**APPLICATION
 FOR PERCOLATION TESTING AND SITE EVALUATION**

LOT 1G PERC CERTIFICATION PLAN

BELLE HAVEN ESTATES
2822 BRIDALWREATH COURT
WOODBINE, MARYLAND 21797
TAX #: 373804, SUBDIVISION: 1401

DATE: 08/09/2021
SCALE: 1"=30'
DESIGNED BY: BKC
DRAWN BY: MM
LOT 16 PERC CERTIFICATION PLAN
BELLE HAVEN ESTATES
2822 BRIDALWREATH COURT
WOODBINE, MARYLAND 21797
TAX #: 373804, SUBDIVISION: 1401
DRAWING NO. SHEET 1 OF 1 KCI JOB NUMBER

LOT 1G PLAN VIEW

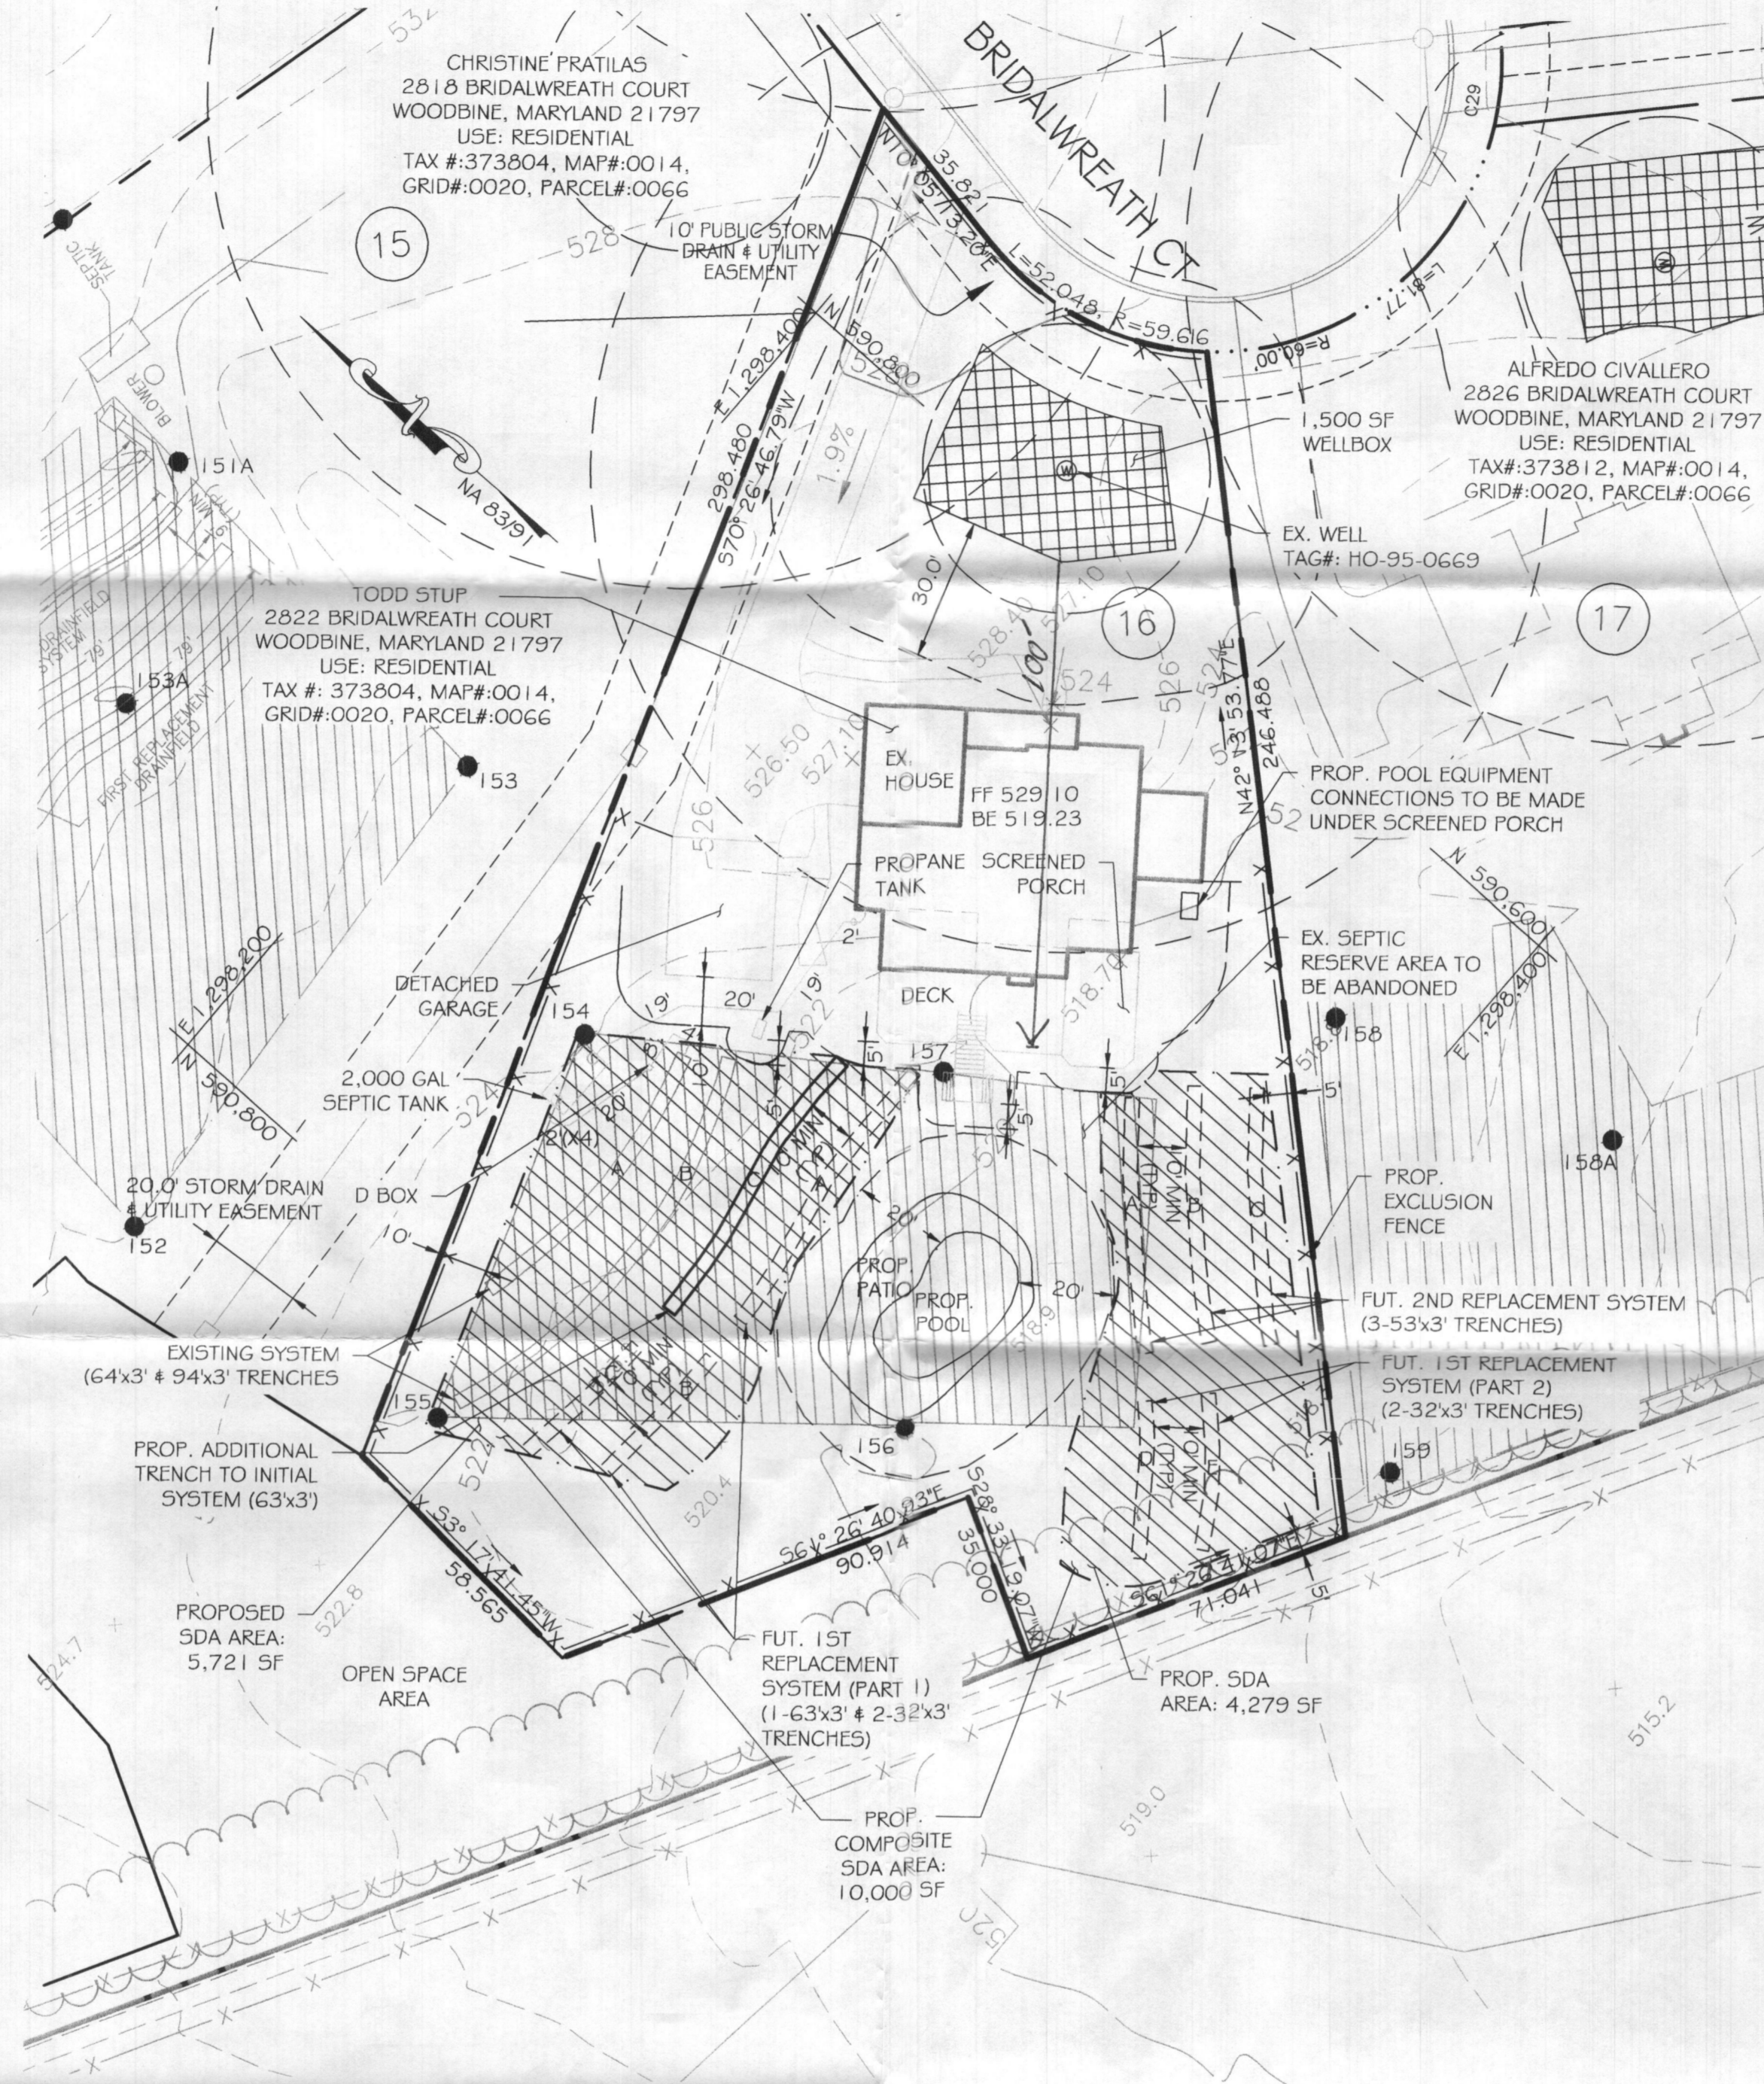
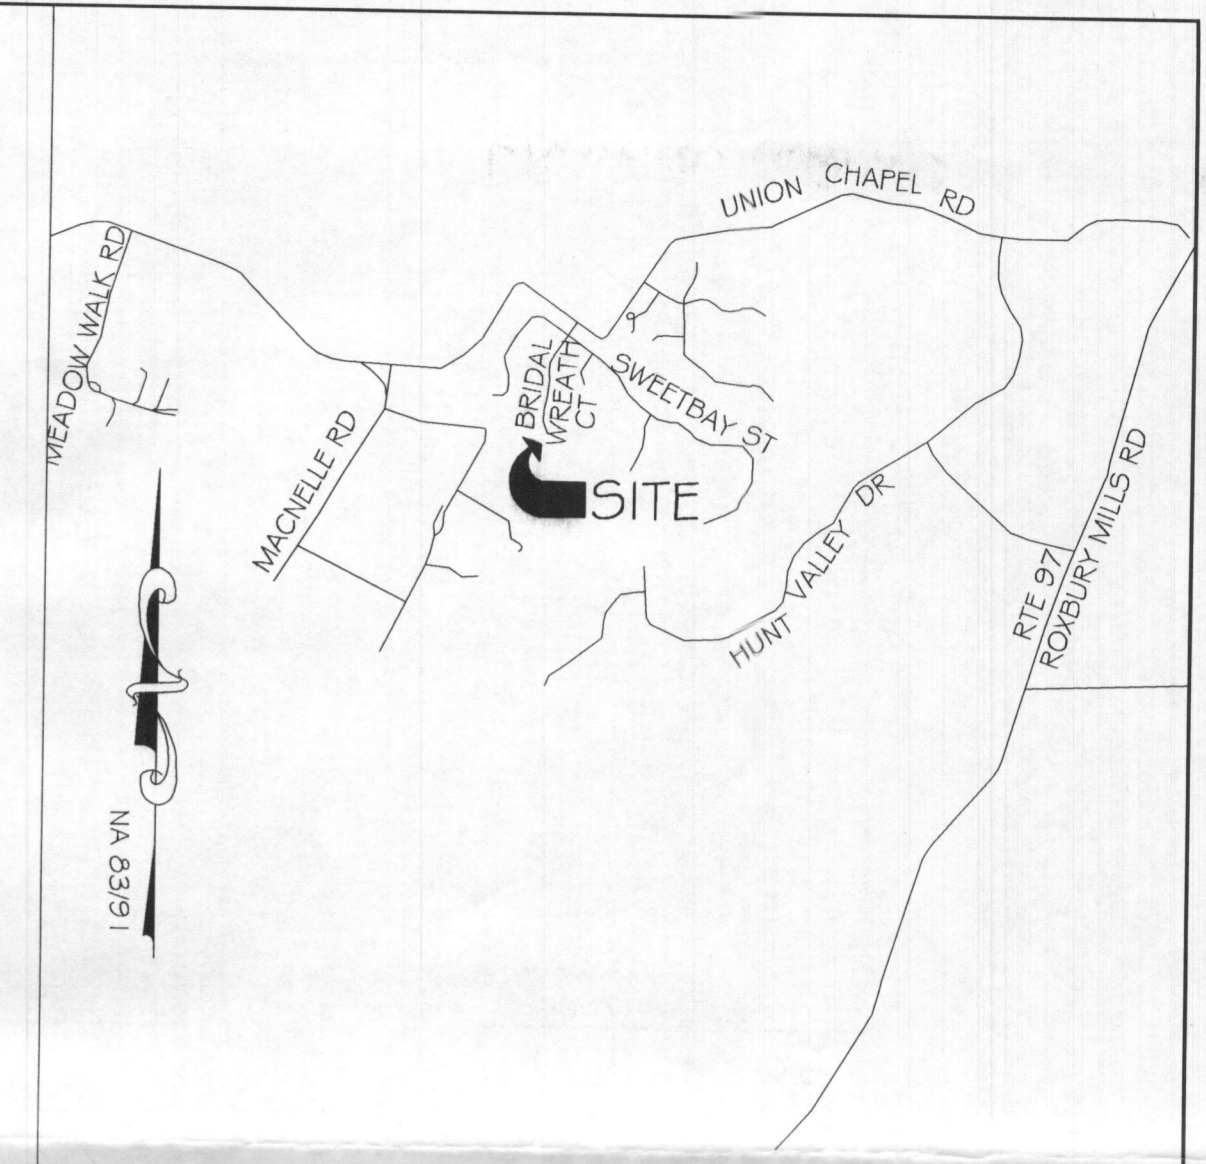
NOTE:
THE PURPOSE OF THIS REVISION IS TO ADJUST THE SEPTIC TRENCH LOCATIONS TO ALLOW SPACE FOR AN IN-GROUND POOL TO BE INSTALLED. IT IS ALSO TO ADD AN ADDITIONAL TRENCH TO THE INITIAL SYSTEM TO ACCOUNT FOR THE FIRST FLOOR LIBRARY, WHICH QUALIFIES AS A BEDROOM, AND THE ADDITION OF A BEDROOM IN THE BASEMENT.

LOT 16 PLAN VIEW
SCALE: 1"=30'

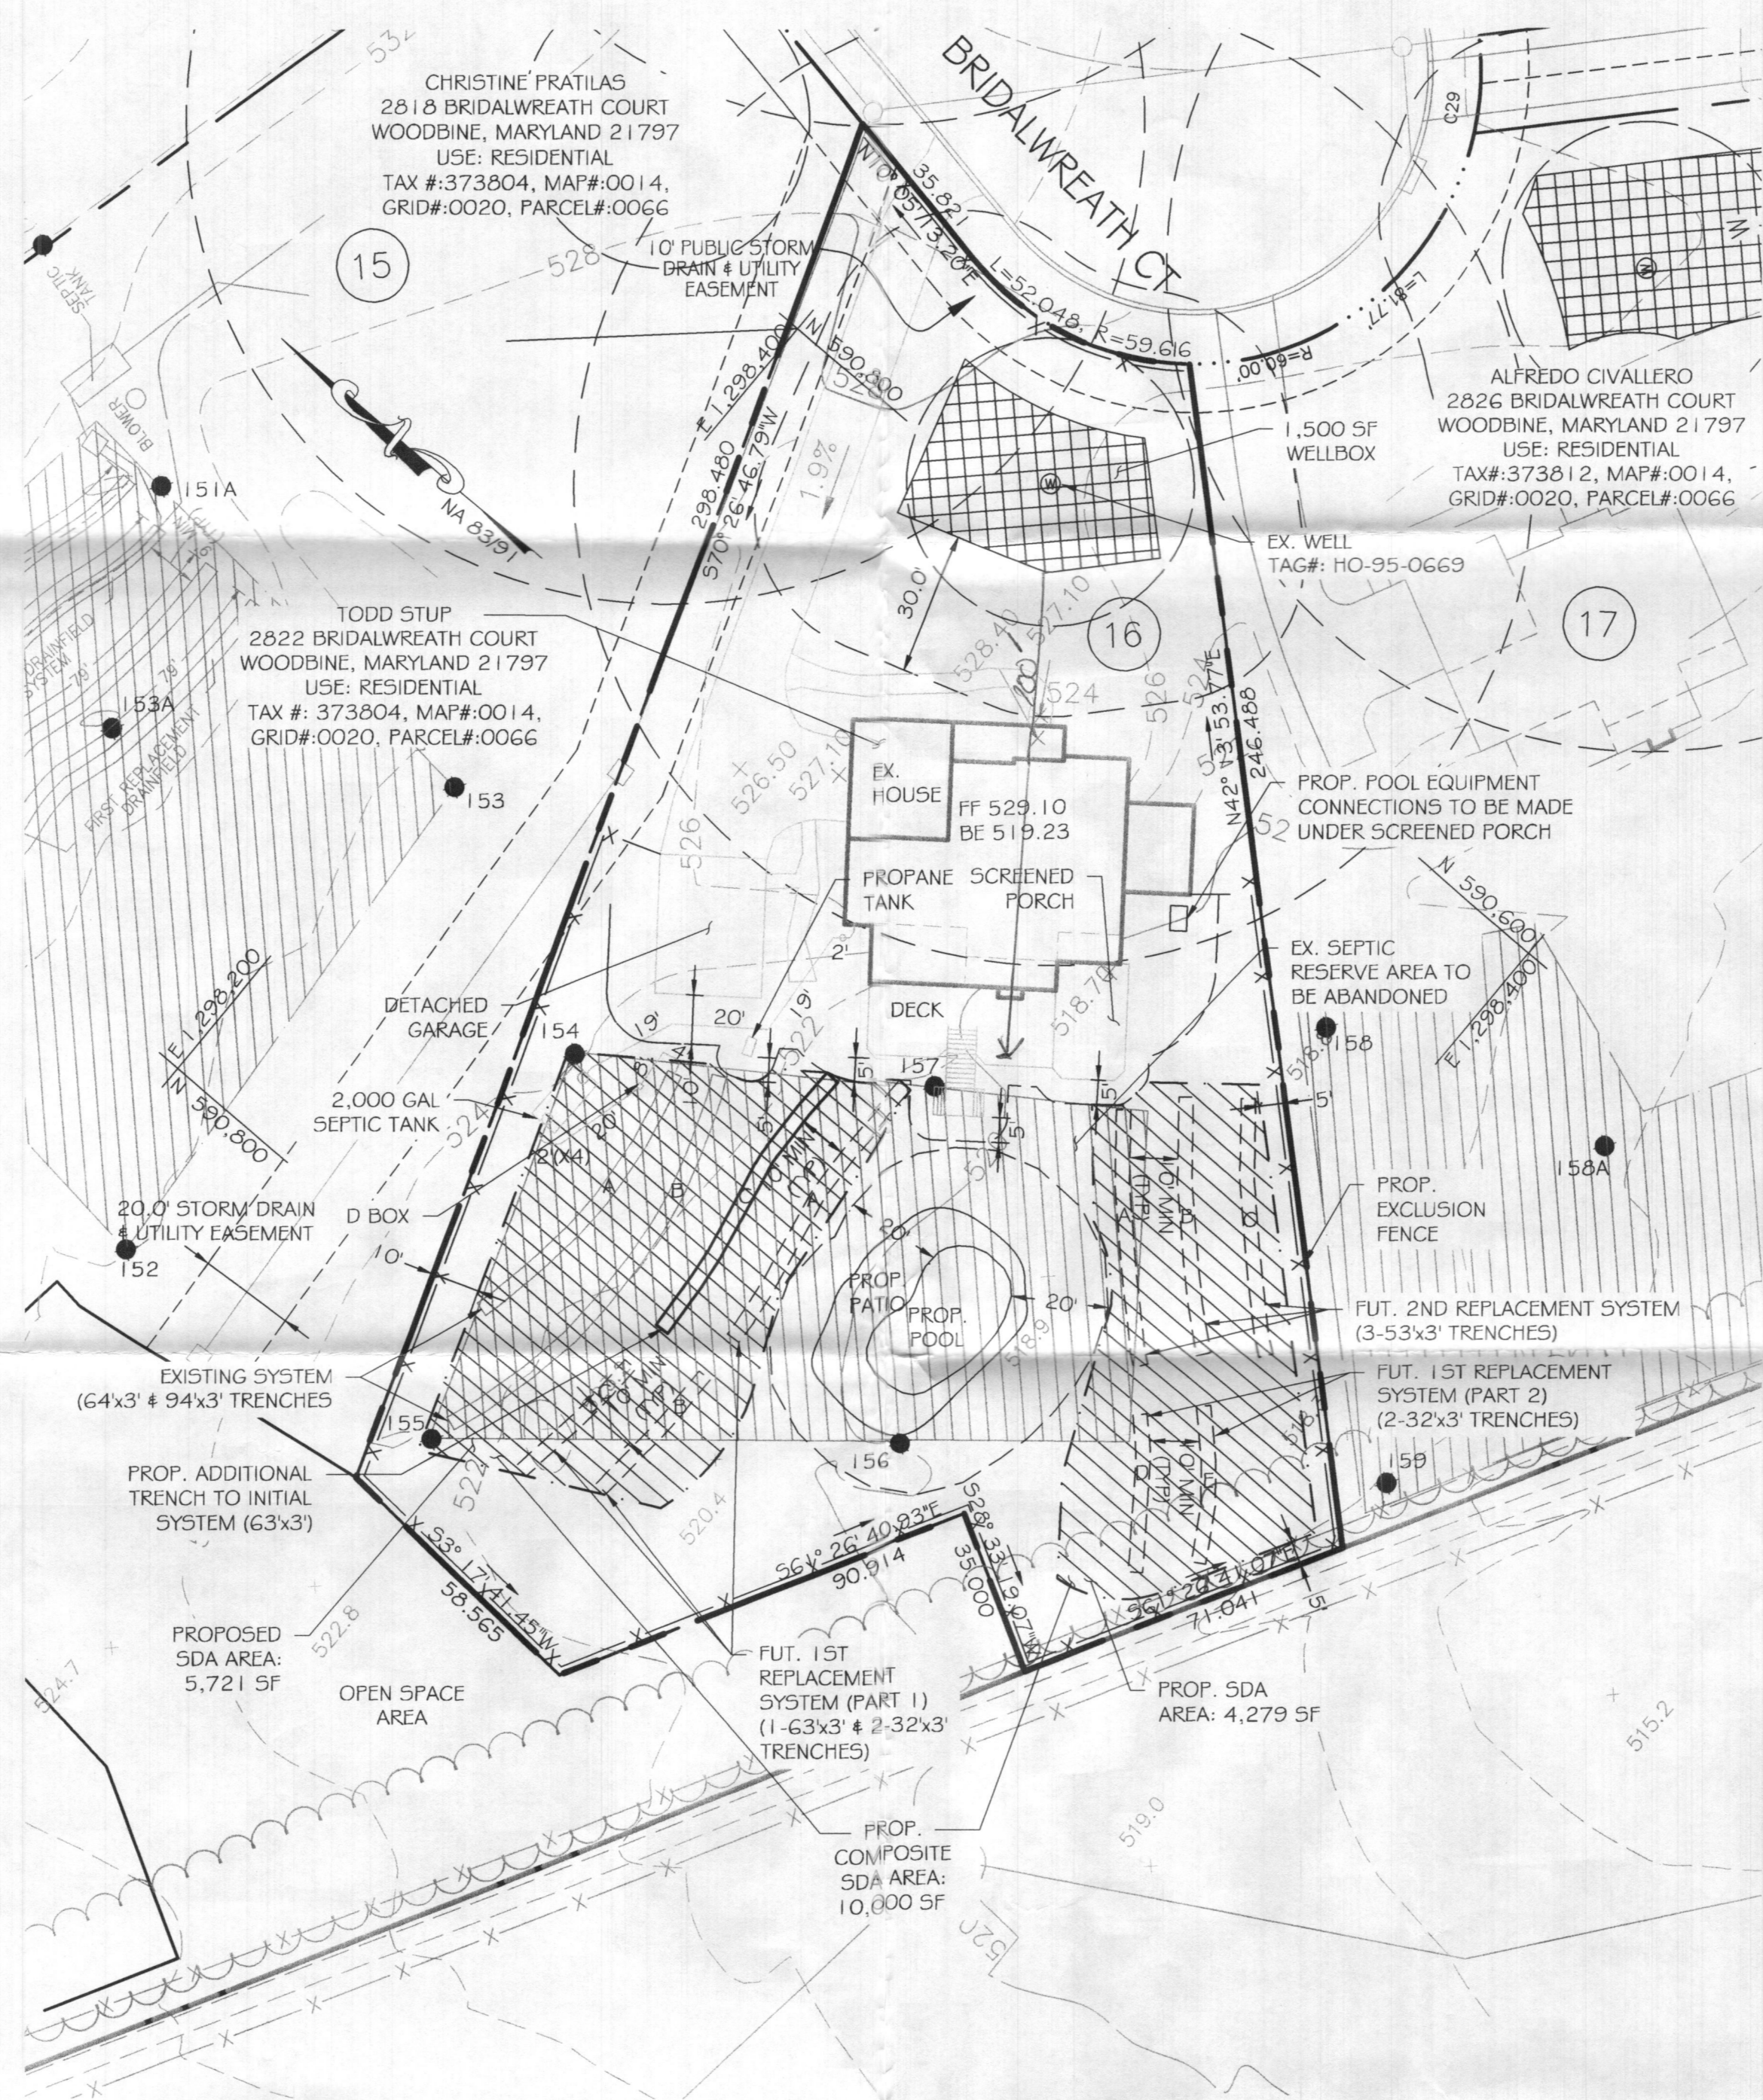
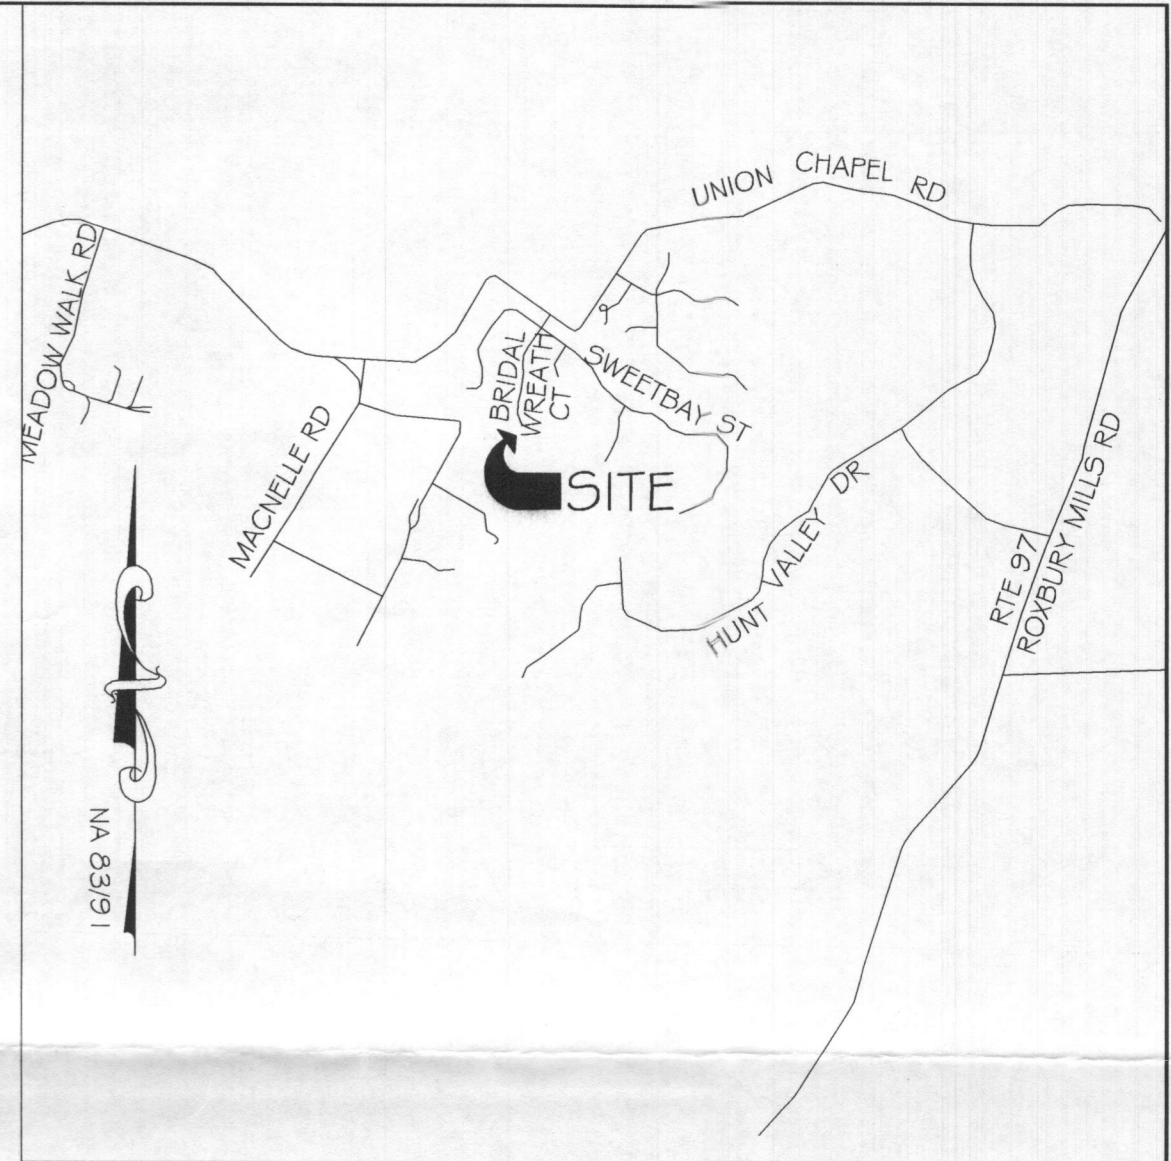
NOTE:
THE PURPOSE OF THIS REVISION IS TO ADJUST THE SEPTIC TRENCH LOCATIONS TO ALLOW SPACE FOR AN IN-GROUND POOL TO BE INSTALLED. IT IS ALSO TO ADD AN ADDITIONAL TRENCH TO THE INITIAL SYSTEM TO ACCOUNT FOR THE FIRST FLOOR LIBRARY, WHICH QUALIFIES AS A BEDROOM, AND THE ADDITION OF A BEDROOM IN THE BASEMENT.
